**HERITAGE IMPACT ASSESSMENT
IN RESPECT OF THE YAU MA TEI THEATRE PHASE 2
AT YAU MA TEI, KOWLOON**

**SUPPLEMENTARY INFORMATION ON THE
REVISED DESIGN OF THE YAU MA TEI THEATRE PHASE 2**

Architectural Services Department
September 2020

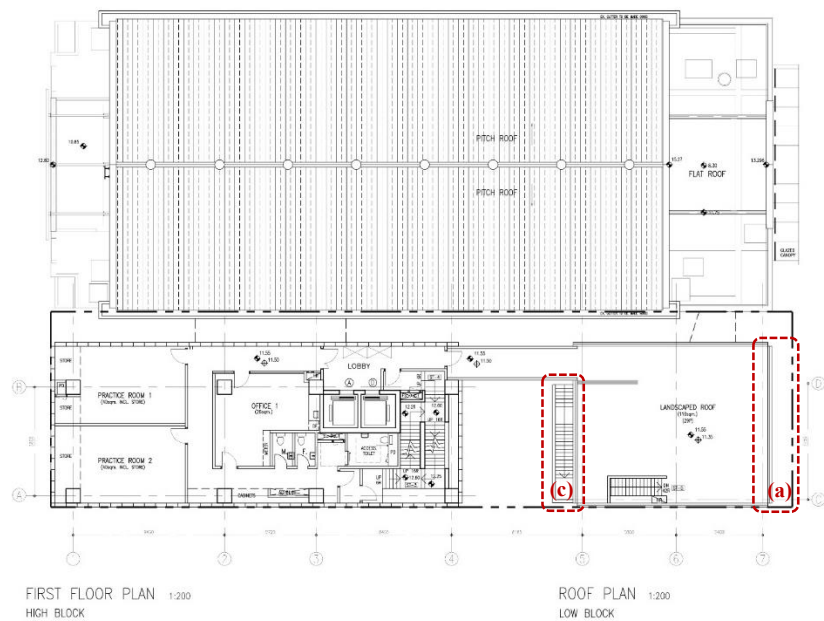
2. Some Members appreciated the design as the proposed high block had been set back from Waterloo Road and located at the rear portion of the Project Site which could minimise the visual impact to the main façade of YMTT. Some Members expressed concern on the visual impact of YMTT Phase 2 on YMTT, a Grade 2 historic building, which is summarised as below –

- a) the frontage of the low block elevation was aligning the site boundary and the pedestrian pavement along Waterloo Road, which would block a front corner of YMTT when viewing from Waterloo Road;
- b) the staircases and lift core of the proposed low block had occupied a lot of area on G/F;
- c) whether the proposed low block could be removed and compensated by adding two more storeys to the proposed high block; and
- d) whether there was the need to re-provide the public toilets at the Project Site and adjacent to a Grade 2 historic building.

- a) set back the frontage of the proposed low block by approximately 1.1m to expose more of the corner and front elevation of YMTT when viewing from Waterloo Road **(Figures I, II and IV)**;
- b) relocate the theatre toilets from previous M/F to G/F, and thus remove the need of internal staircases and lift core of the proposed low block to provide more space on G/F **(Figure I)**;

- c) replace the internal staircases of the proposed low block with an external open staircase leading from G/F to landscape roof for better appreciation of the east elevation of YMTT **(Figures I and II)**;
- d) reduce the massing and lower the building height of the proposed low block by approximately 0.7m for better appreciation of the pitched roof and roof feature of YMTT **(Figures III and IV)**; and
- e) enhance the visibility of the east elevation of YMTT by the circulation design and the use of glass wall with various transparency in the low block **(Figures I, IV and V)**.

Figure I. Proposed Ground Floor Plan (Low Block) - (a) the frontage of the proposed low block is set back by approximately 1.1m; (b) & (c) the internal staircases and lift core are removed and replaced with an external open staircase leading to landscape roof to provide more space on G/F; (e) the circulation is designed to enhance the appreciation of the east elevation of YMTT.
